ADDENDUM NO. 2

**Project: Project #: 403
Bus Electrification and Site Improvements**

ADDENDUM A

Revised DC fast Charger per owner direction, for BorgWagner model RES-DCVC 60-480, charger and 2 Dispensers. The following modify or supplement the original drawings:

E1.1
ADDENDA A

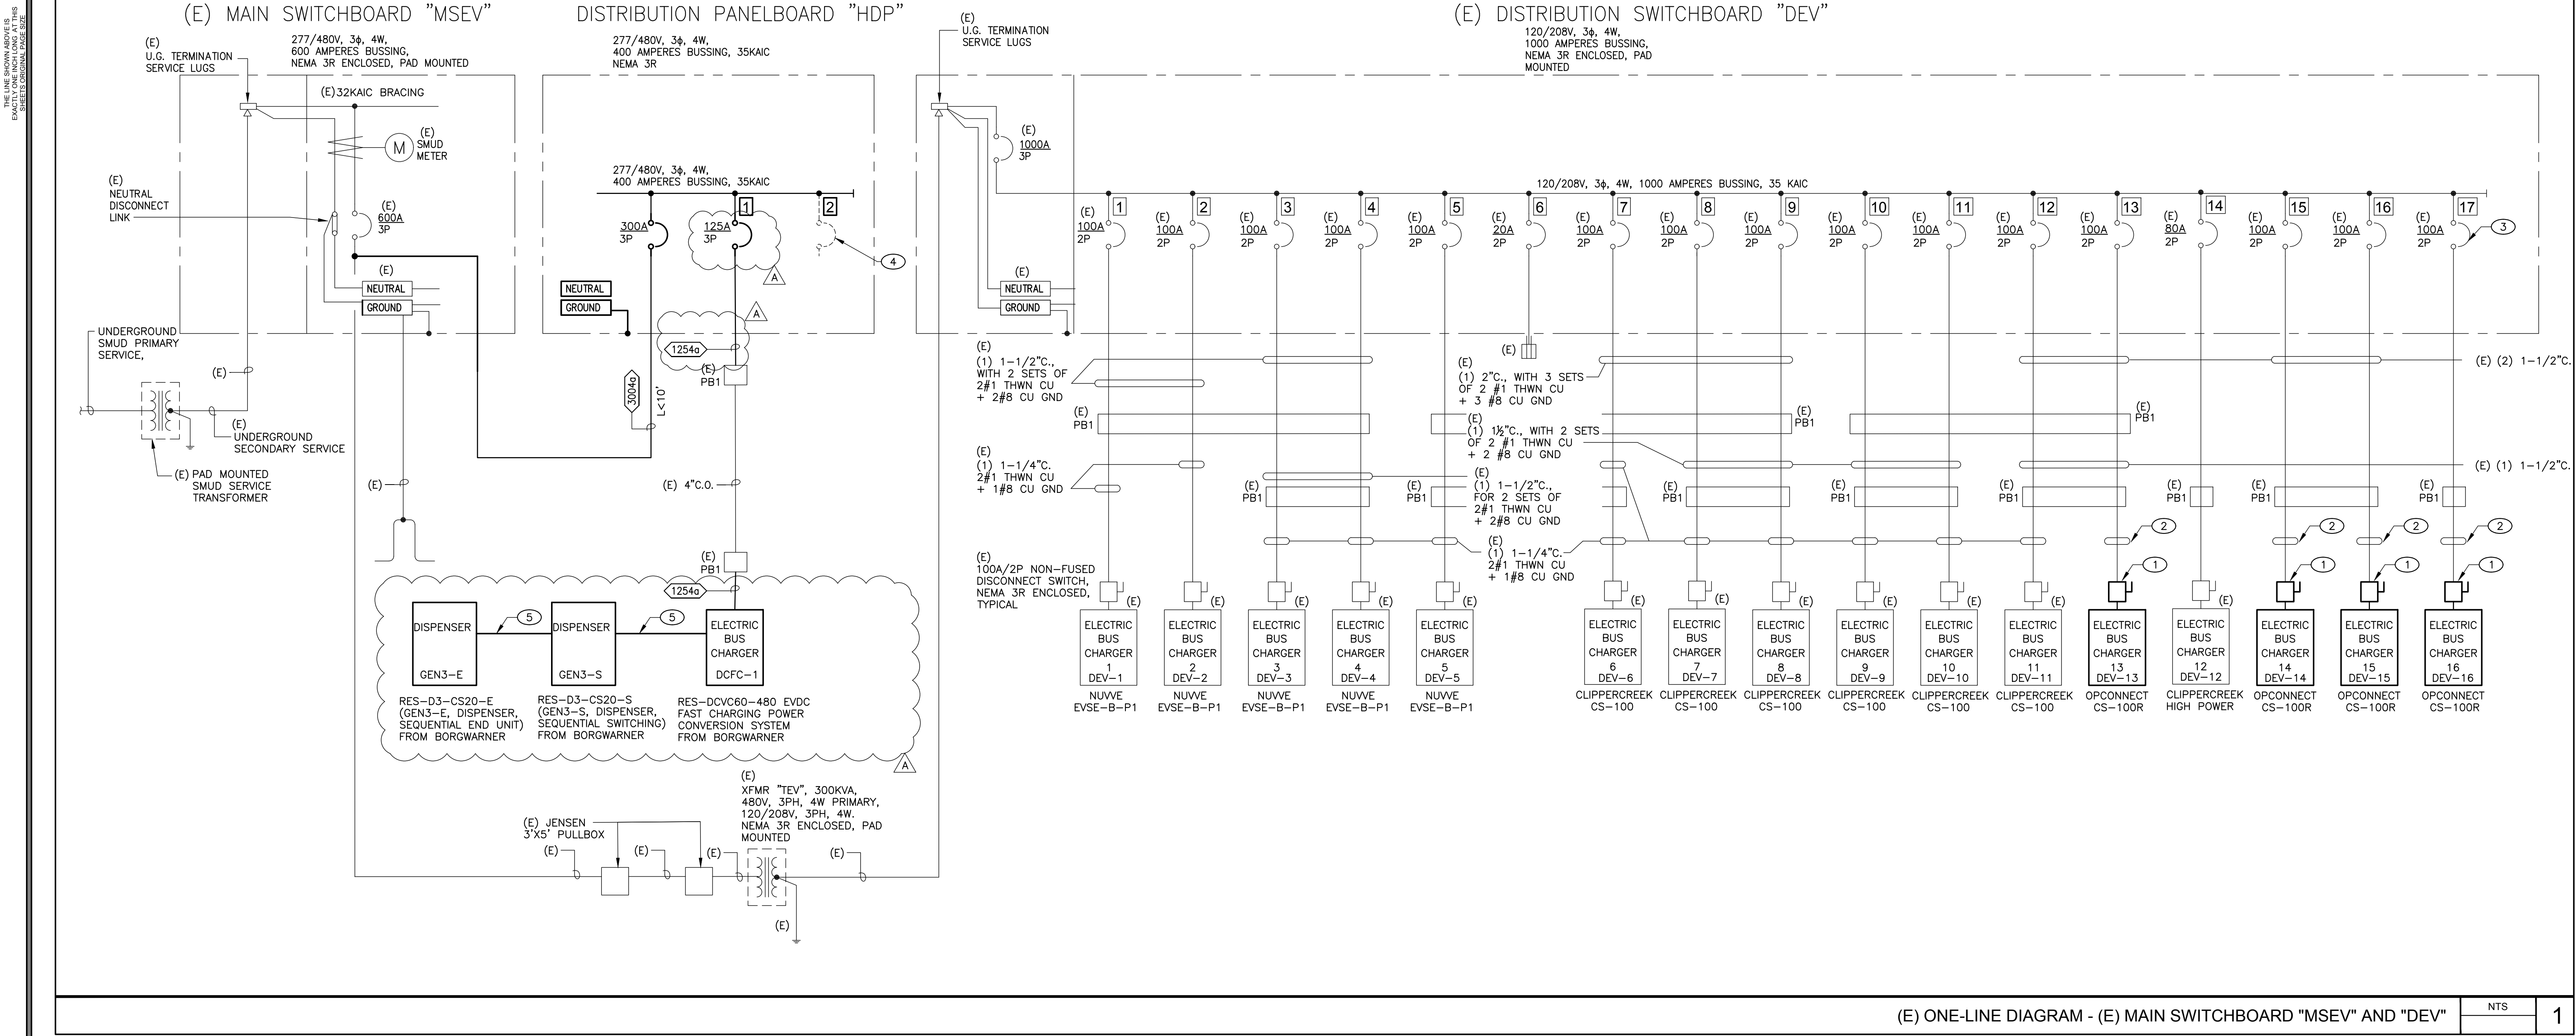
QUESTION #2: Could you please clarify the 1" conduit that needs to be provided referenced to on page E1.1 Keynotes #4? Is conduit in questions existing and just needing to be rerouted from a near by location into the base of the new DC Fast Charger? Or is it going to require to be installed new, to the building? The E1.1 page does not express if it is a new install or existing?

Item No. AD A-1: Clarify 1" Conduit on Sheet E1.1 Keynote #4

Question – “Clarify the 1" conduit that needs to be provided referenced to on page E1.1 Keynotes #4? Is conduit in questions existing and just needing to be rerouted from a nearby location into the base of the new DC Fast Charger? Or is it going to require to be installed new to the building? The E1.1 page does not express if it is a new install or existing?”

RESPONSE: All existing conduit on the plan is shown in a light color with the word 'existing' or the abbreviation '(E)'. This 1" conduit is new, and the contractor shall field verify if the site has an internet connection near the fast charger. Otherwise, the contractor needs to provide an underground conduit, route it close to the wall, and connect it to the wall-mounted weatherproof J-box. It should be labeled as the 'Fast Charger Internet Connection Point'.

Response - *All existing conduit on the site plan is shown in a light color with the word 'existing' or the abbreviation '(E)'. This 1" conduit is new, and the contractor shall field verify if the site has an internet connection near the fast charger. Otherwise, the contractor needs to provide an underground conduit, route it close to the wall, and connect it to the wall-mounted weatherproof J-box. It should be labeled as the 'Fast Charger Internet Connection Point'.*
